**GEOTECHNICAL AND GEOLOGIC HAZARD INVESTIGATION
The Ridge Nests Development
Powder Mountain Resort
Weber and Cache Counties, Utah**

IGES Project No. 01628-008

July 15, 2016

Figure
A-2

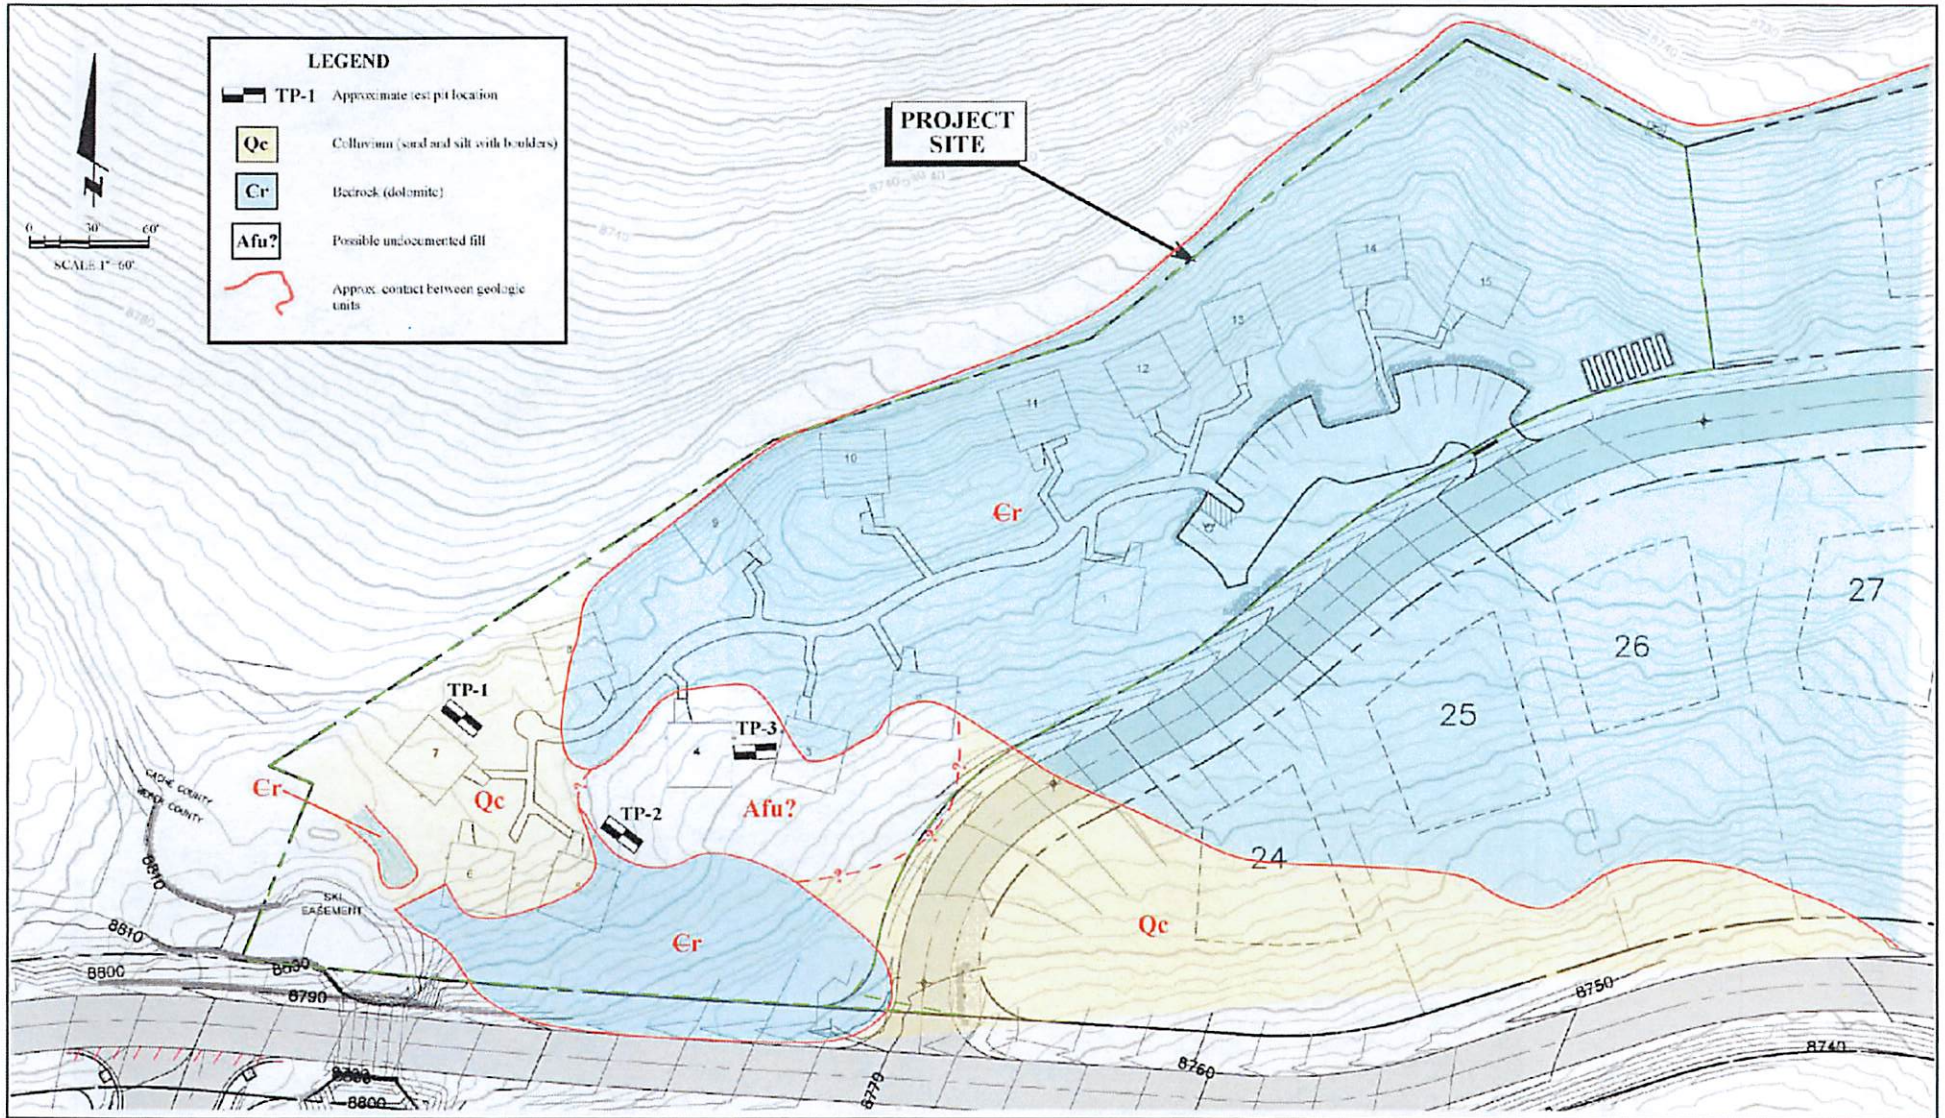
“Figure A-2, Geotechnical Map, of the September 16, 2014 IGES report depicts “...the relative locations of the various geologic units...” described in the September 16, 2014, IGES report. SA recommends Weber County request IGES:

A geologic investigation of Lot 13 and the immediate area surrounding the Ridge Nests subdivision was conducted by an IGES engineering geologist between August 26 and 27, 2015. Plate 1 (*Geologic Map*) is an updated, expanded version of the original Figure A-2, *Geotechnical Map*, from the IGES geotechnical report. The geologic mapping has been extended to several hundred feet in all directions from the original map, and minor modifications to the original geologic contacts have been made based upon the findings of the investigation. Additionally, bedding and jointing attitudes, and the approximate locations and orientations of identified faults are presented on the map. Two geologic cross-sections providing a representative picture of the subsurface of the property are illustrated on Figure 1. A brief description of the findings of the geologic investigation follows.

Summit/Ridge Nests; A-A'; Static; bedding 24 deg apparent dip

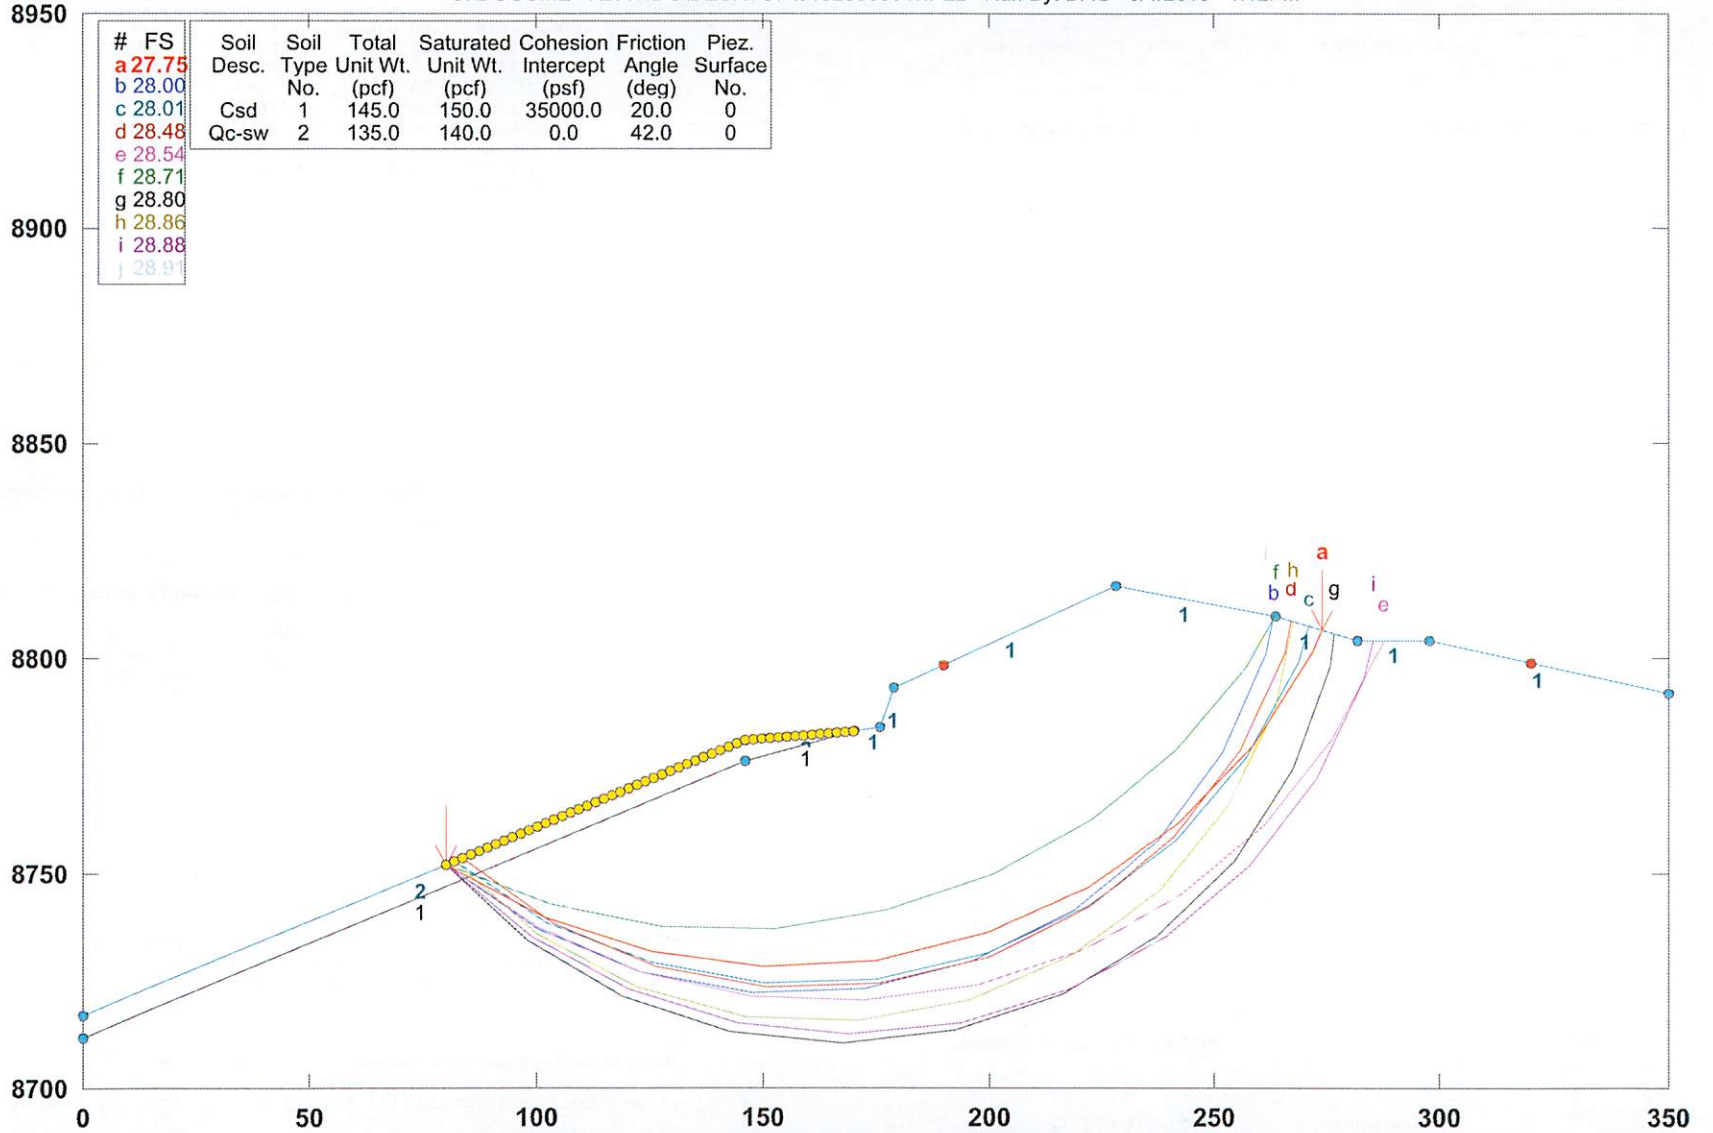
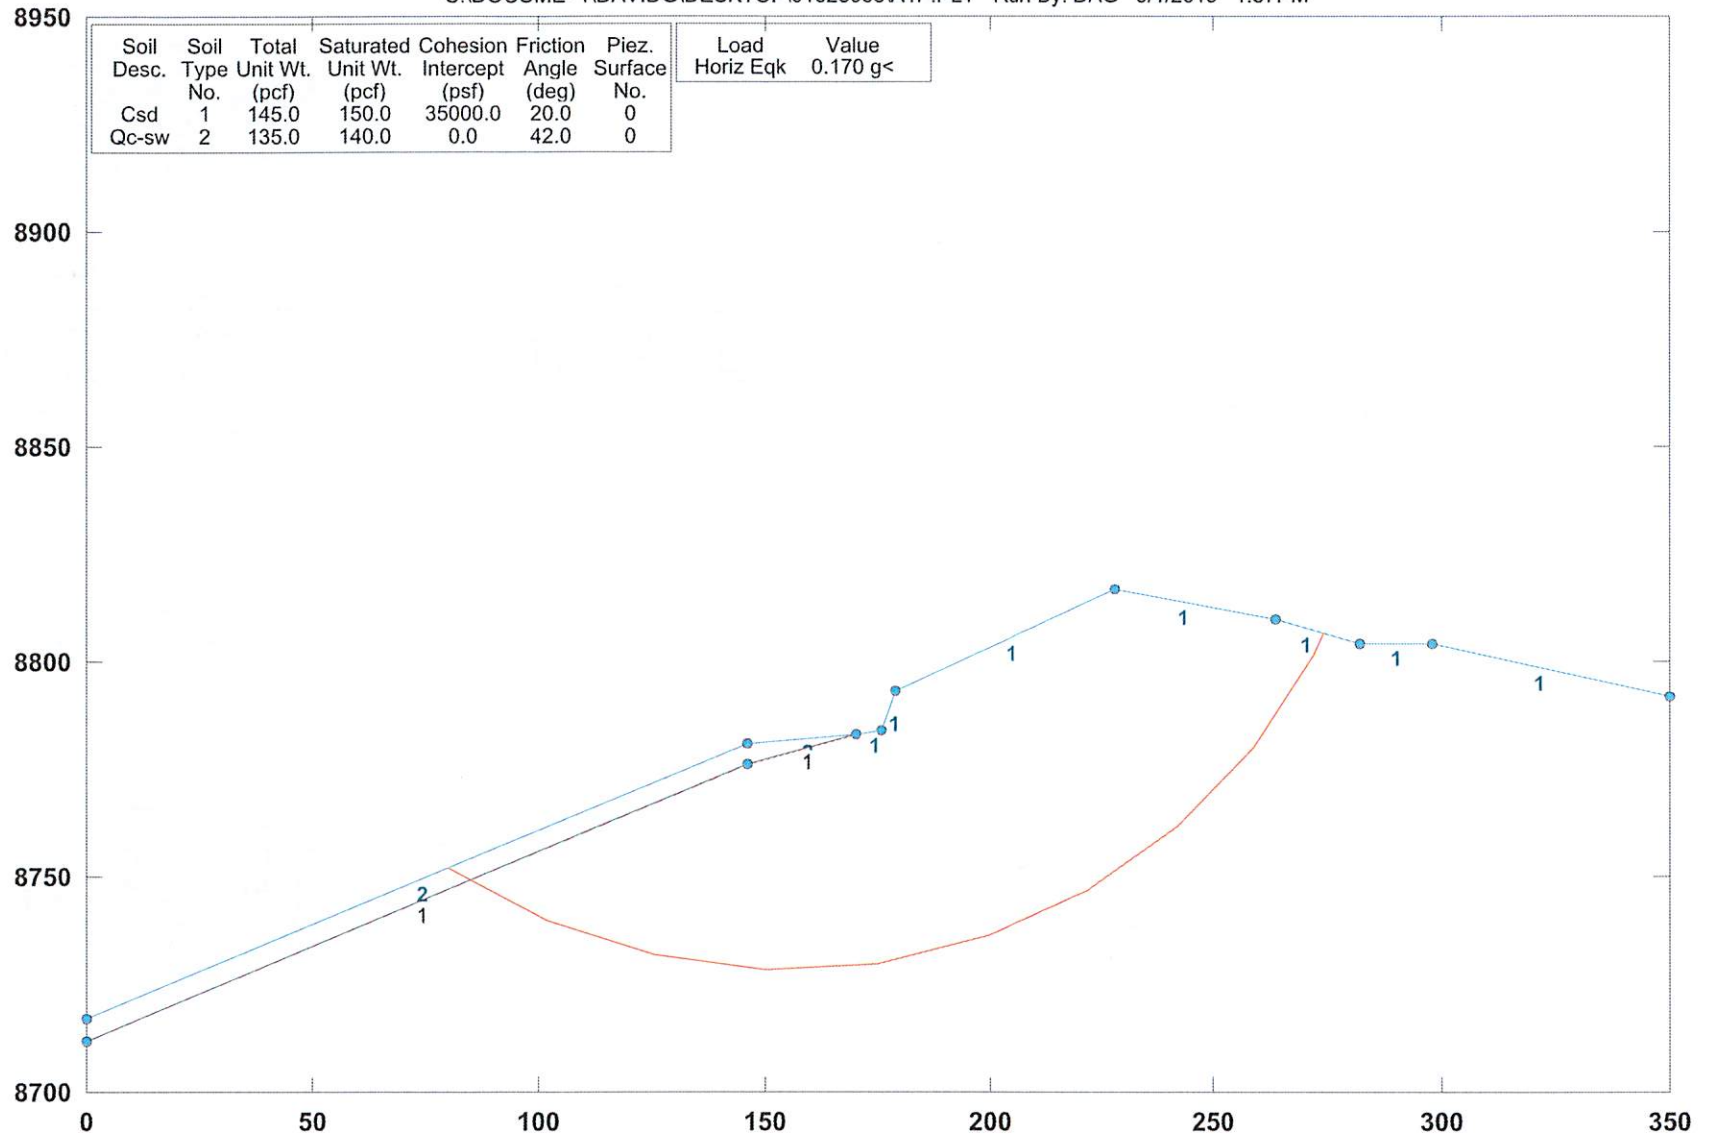
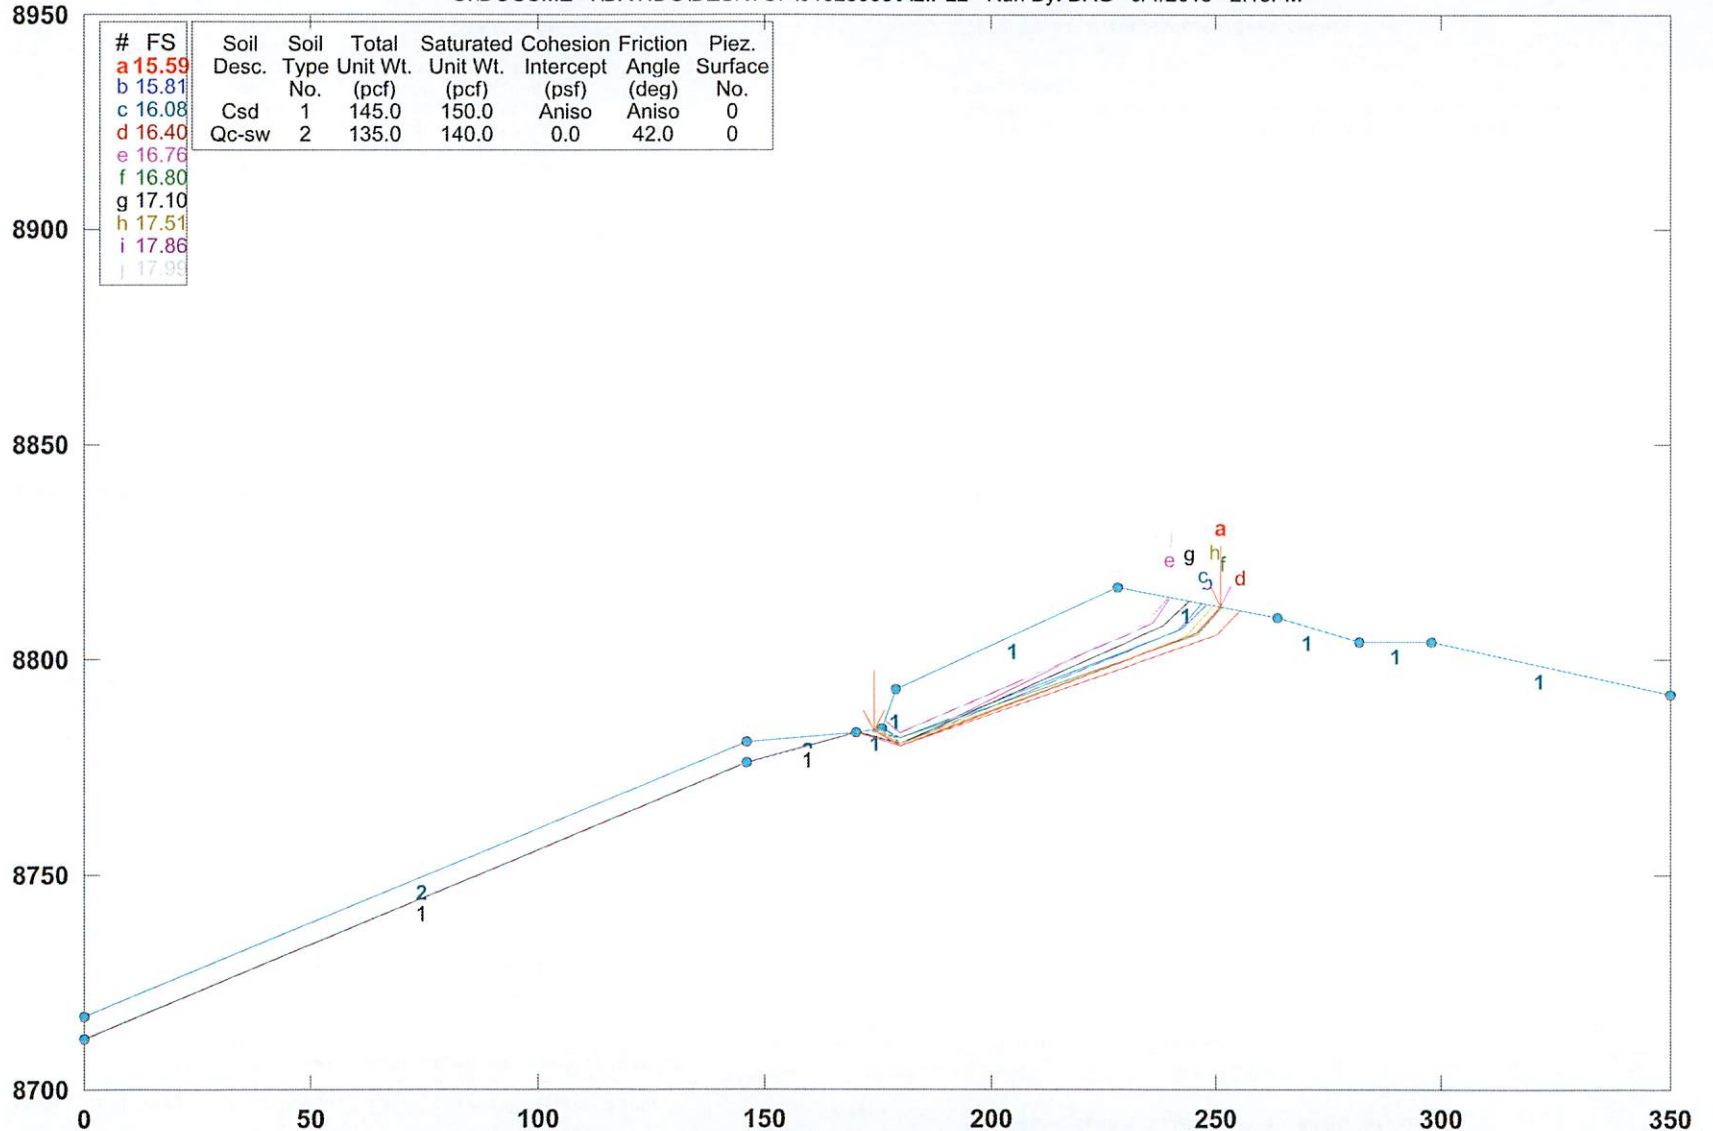
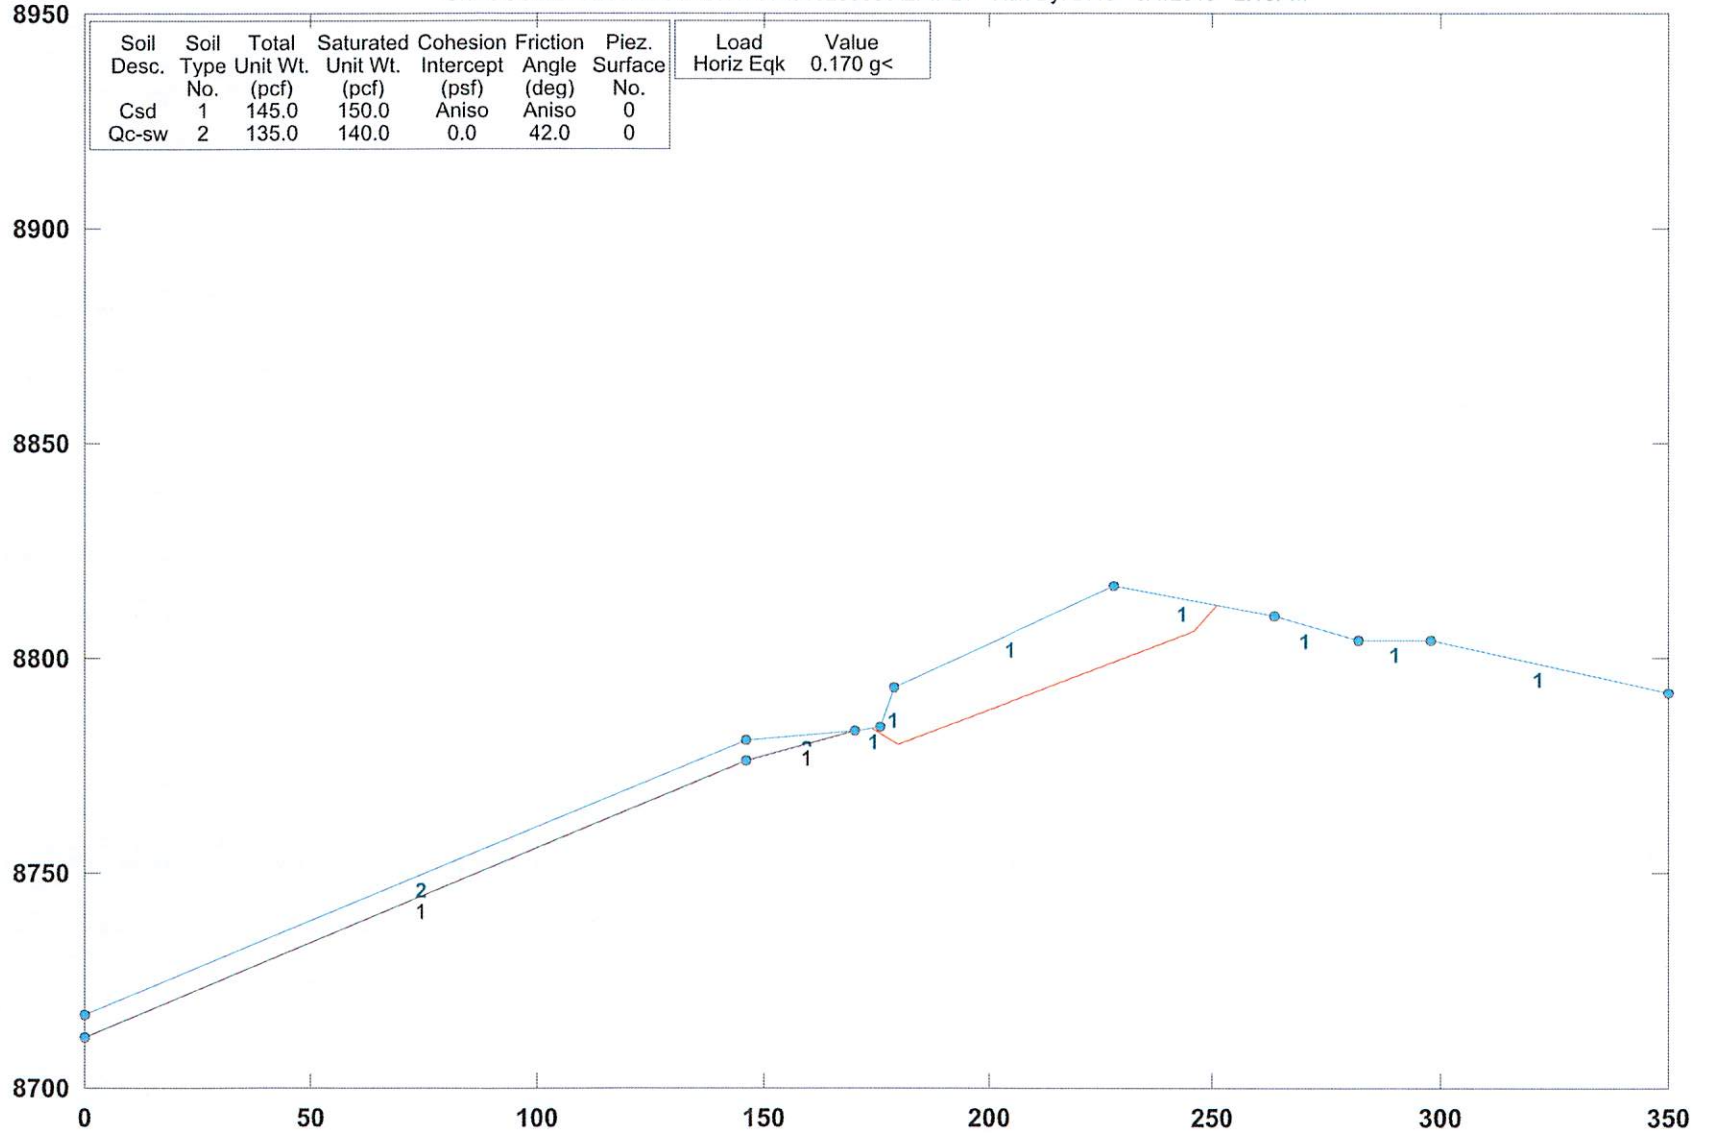
Comment No. 1

The global stability of the slope was modeled using gSTABL7 slope stability software. Bishop's Method and Janbu's Simplified method was used to model the slope, as appropriate. For our analysis, we have assessed two representative sections, Section A-A' and Section B-B', illustrated on Plate 1 (*Geologic Map*) and the *Geologic Cross-Sections*, Figure 1, attached. Calculations for stability were developed by searching for the minimum factor-of-safety for both a circular-type failure and a block-type (translational) failure. For the circular analysis model, arcuate failure surfaces and homogenous earth materials were assumed. For the block analysis, anisotropic strength parameters in the bedrock was assumed, based on the apparent dip of bedding. A minimum static factor-of-safety of 1.5 and seismic factor-of-safety of 1.0 (global stability) was considered acceptable for this project considering the available information and design assumptions.
